Re: Appeal of Preliminary Mitigated Negative Declaration Regarding Alcatraz Ferry Embarkation Project (Case No. 2017-000188ENV)

**SUBJECT:** Second Addendum to the 2012 Initial Study/Mitigated Negative Declaration and 2017 Addendum for the Sausalito Ferry Terminal

## Responses to Questions from the City of Sausalito Received June 9, 2016

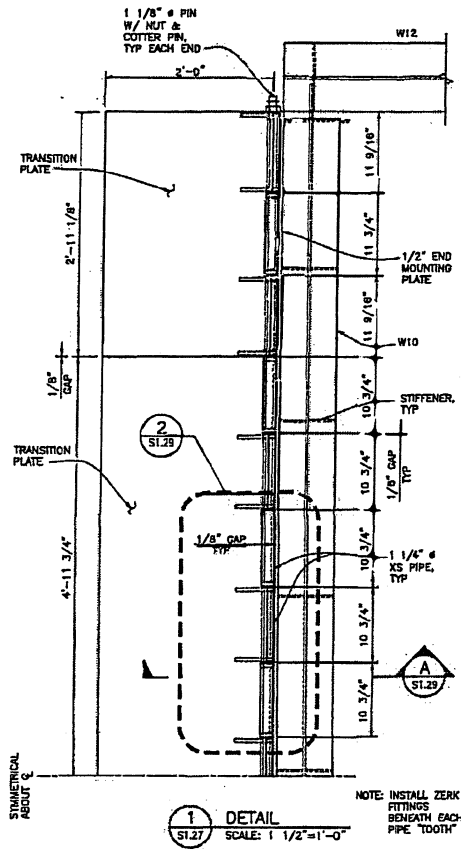
4. *The boarding platform is 79.5' long (Ref. A: page 4 of 7 last paragraph, Figure 6, Drawing S1.2, Float-Dimensions Discussion-Length) whereas the outside-to-outside distance of the vessel doors is 56.0'. Please clarify if the boarding platform length can be optimized.*

A: This distance has been re-evaluated and optimized to the extent possible. The center to center spacing between ferry doors is 48' and the clear width door opening is 8' per door, therefore the distance between the clear door opening of both doors is 56'. The remaining 23.5' of the boarding platform length accounts for the sliding gates for the gangplanks, hydraulic lift cylinders, and an employee-only access ramp required to access the aft end of the float for maintenance. Please see page 6, Figure 6 on page 7, Figure 8 on page 8, Figure 9 on page 9 and page 12 of the "Proposed Float Size Discussion – For City of Sausalito Peer Review" document dated 5-16-16 for more information.
